LETTER OF SUBMITTAL
KFM Skyway Project# 04-012024

Subject: USI - Documents Clearing USI KFM NCR #47 (METS #33)

PROJECT: SFOBB Skyway Structure

Subject: USINCR No. 33: Failure to Follow Fabrication Procedure Regarding Sequence of Welding

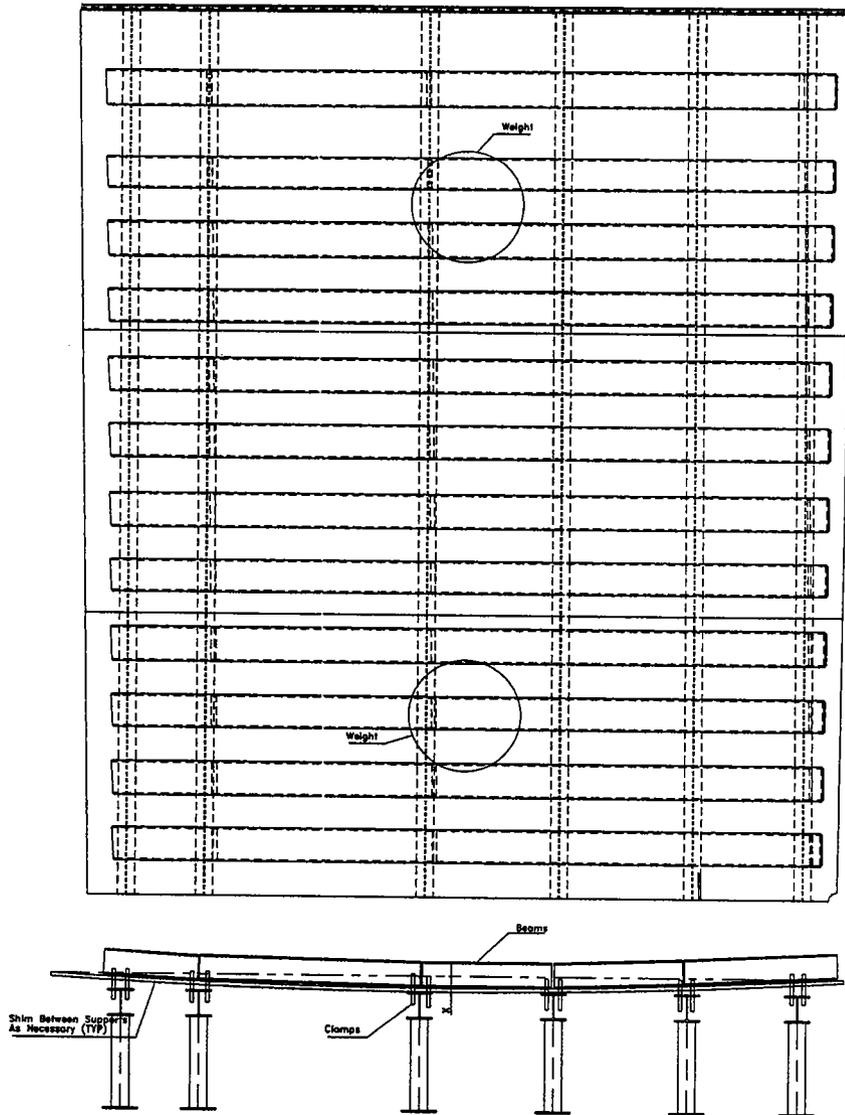
1. Pre-Camber the assembled wing plate according to predetermined dimensions.
2. Attach restraint per Detail "A".
3. ~~Weld ribs starting from the center of the wing transversely.~~ ---DELETED ***REV 11***

Sub Assembly Detail - Web Plate

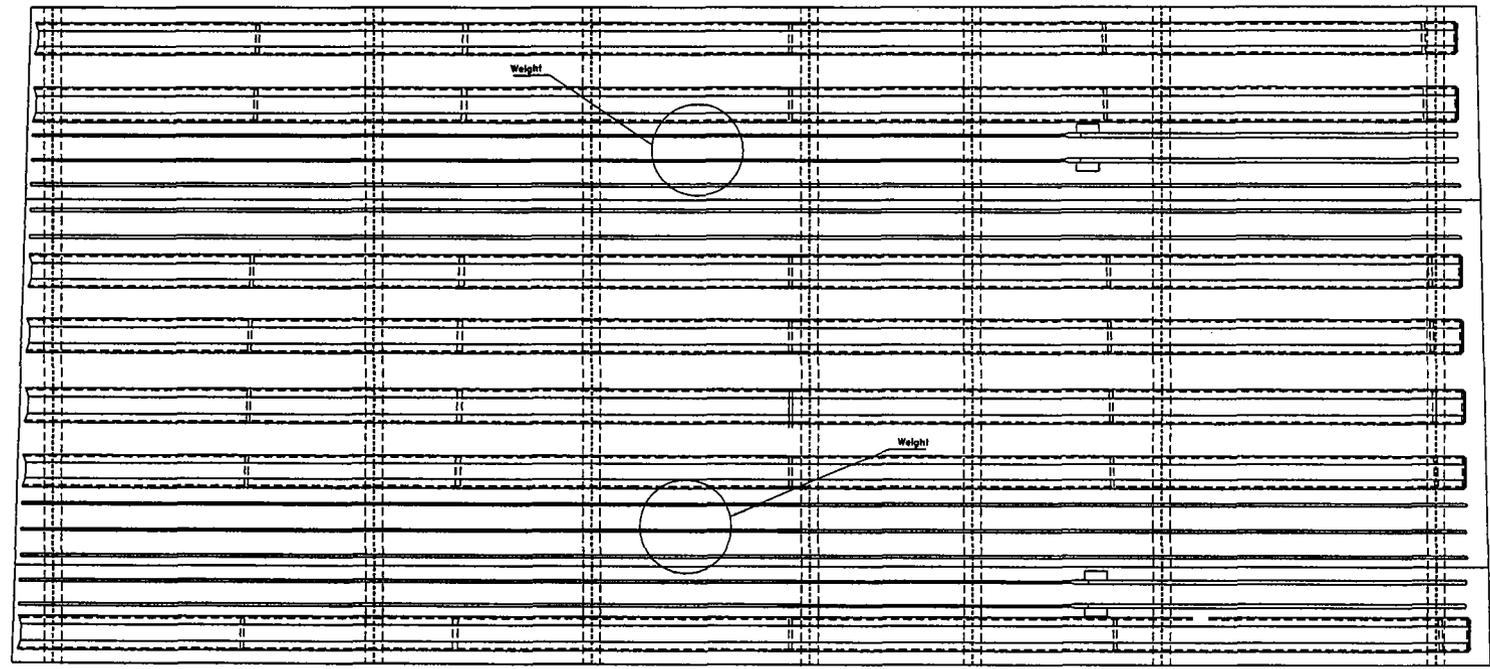
1. Pre-Camber the webs according to predetermined dimensions.
2. Attach restraint per Detail "A".
- ~~3. Weld ribs starting from the center of the web transversely -- DELETED **REV 11**~~

Sub Assembly Detail - Deck Plate (Soffit/Wing)

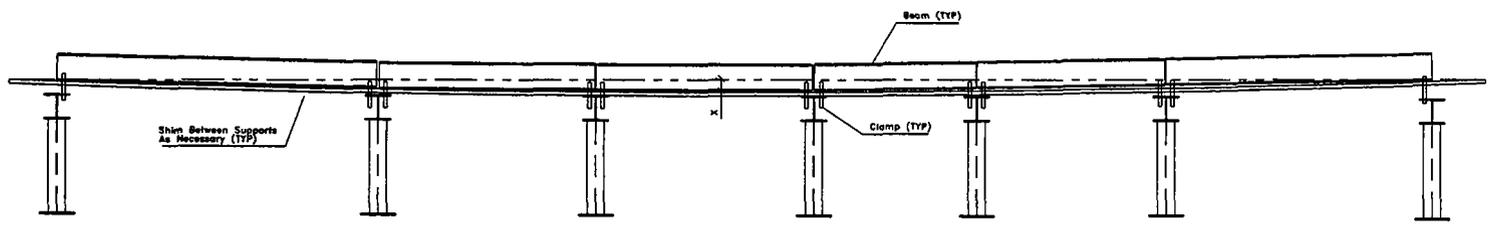
1. Pre-Camber the deck according to predetermined dimensions.
2. Attach restraint per Detail "A".
- ~~3. Weld ribs starting from the center of the deck transversely.~~ --DELETED ***REV 11***
